TITLE RCV-7 Shaft Seamed (OCONEE-1)  
RELATED SPRs SPR (WLT) 446, 461

FILE: 1242  
Contract 620-00 - 03  
SFR 546  
TITLE RC-VI Shaft  
Scored  
DATE 2-19-74

SITE PROBLEM REPORT

CUSTOMER Duke Power Co CONTRACT NO. 620-003 SPR NO. 546 SPR REV NO. 0

FIGURE 1

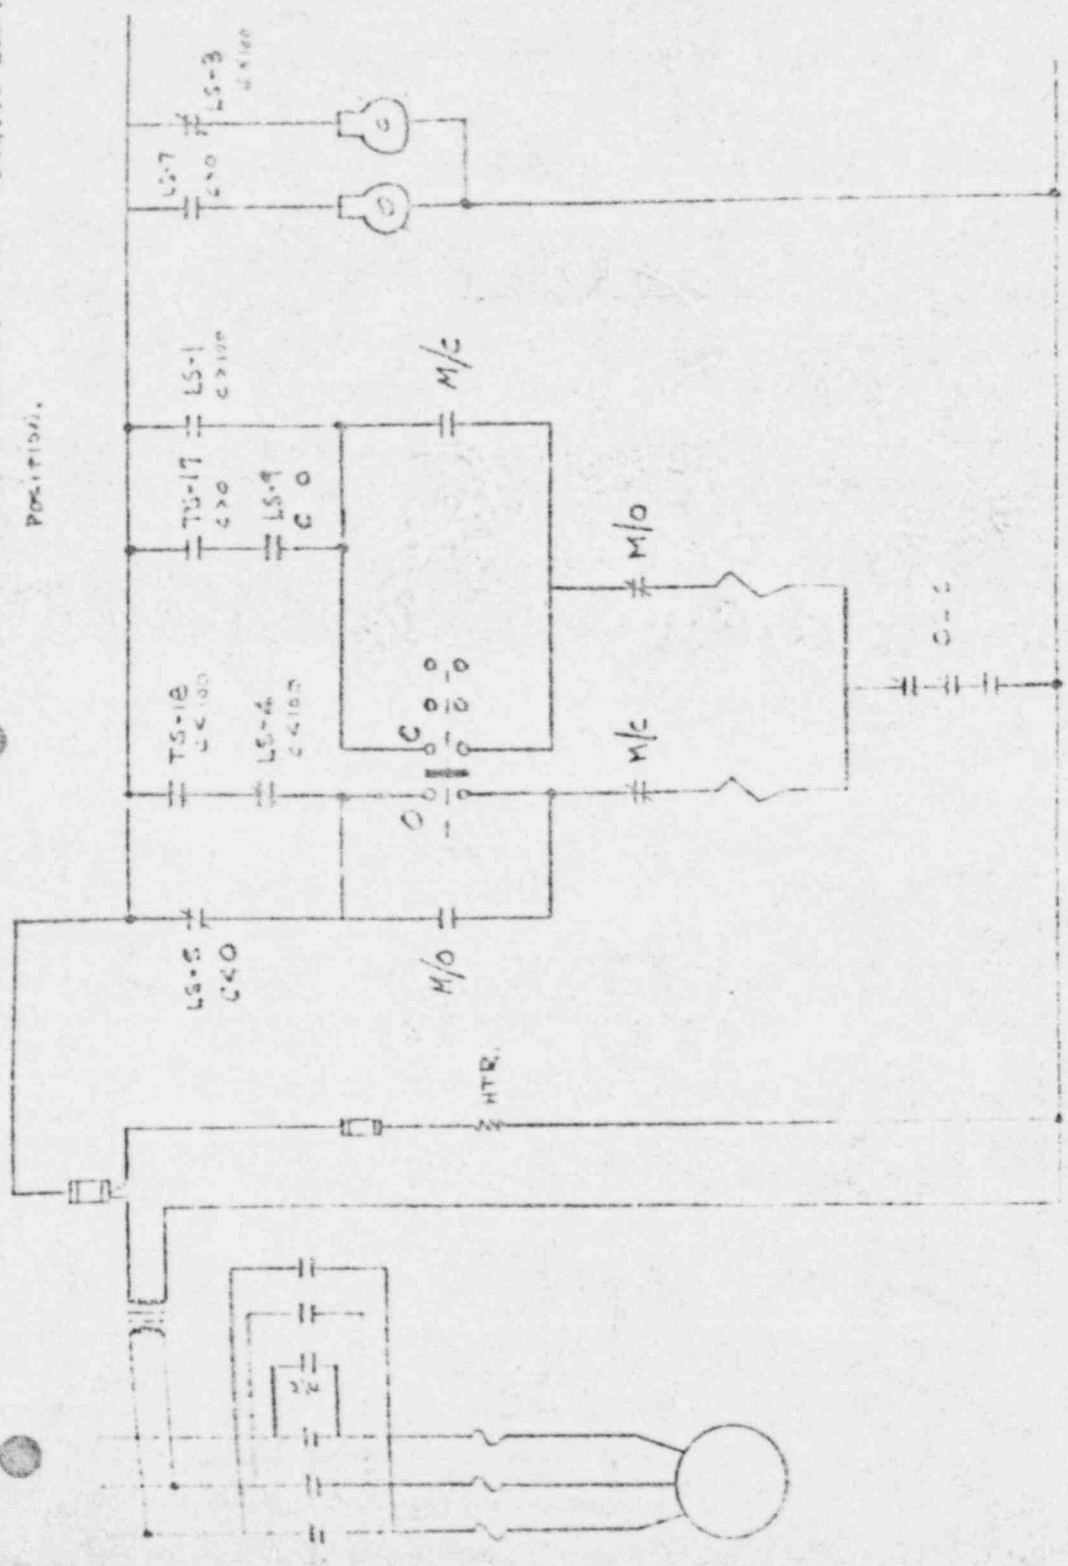
Limit Switch LS-9 was added to the 1 RC-V2 circuit on 12/12/73. (See Fig. 1) The switch was set to stop valve travel at 4 turns of the handwheel from the full closed position. This appears to have solved the opening problem as this valve was opened on 12/16/73 at full temperature and pressure. Now the valve cannot be closed. Two attempts were made on 12/17/73 and both times the overloads tripped. The 15 ft # motor is evidently not strong enough to start the valve toward the closed position.

NOTE: LS-9 ADDED 11/13/73 TO STOP  
 TRAVEL BEFORE FULLY TONGUED CLOSED  
 POSITION.

FIGURE 2

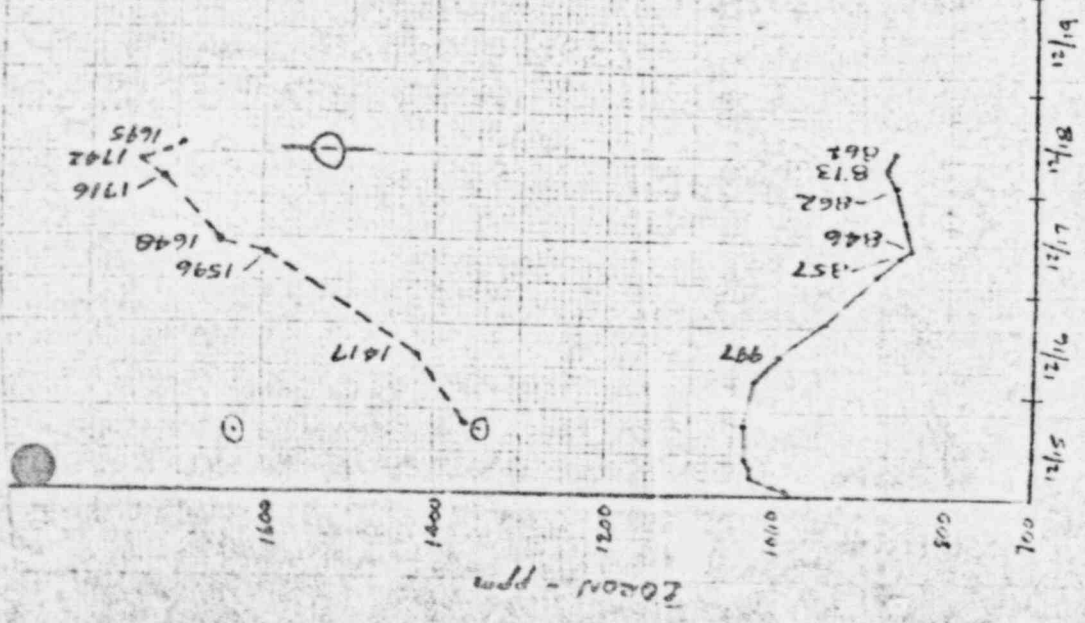
Since 12/15/73 we have been able to obtain comparative RCS and pressurizer boron concentrations. This is in response to SPR-557 and B. A. Karrasch's memo of 11/19/73. Figures 2 and 3 are plots of these values for both Units I and II. The Unit I continuous vent (.1 to .4 gpm) was secured on 12/17/73. Before the system is cooled down, we will investigate for leaking valves, etc. Unit II is indicative of normal operation since a conscious effort has been made to maintain RCS boron concentration constant with only the spray valve bypass flow into the pressurizer.

① STARTED VARYING PAPER LEVEL BETWEEN 220" & 270" @ 0300 12/18/13
